Access Compliance Report

Public Rights-of-Way

Main Street: LOS_ALAMITOS_BLV Cross Street: BRADBURY_RD Location: NE

ADA ID: RPRK211221112625 Ramp Type: Type 4 - Parallel Initial Pass/Fail: Pass Overall Compliance: No Severity Score: 4

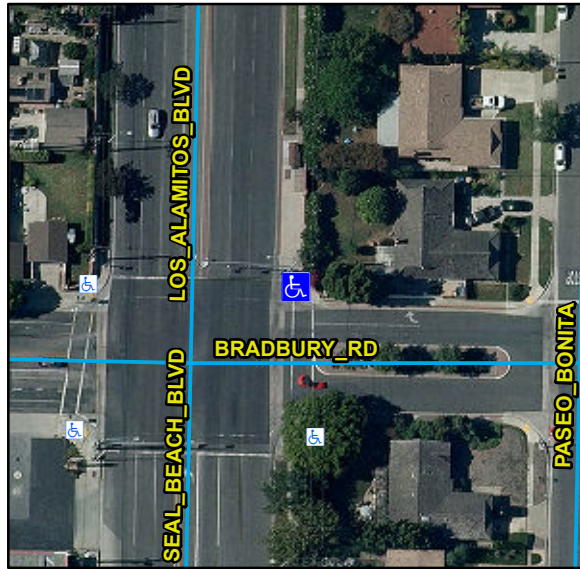
Possible Solutions:

Remove & Replace Curb Ramp With Two New Directional Ramps or Equivalent.

R204.3, R304.2.1, STD 1115
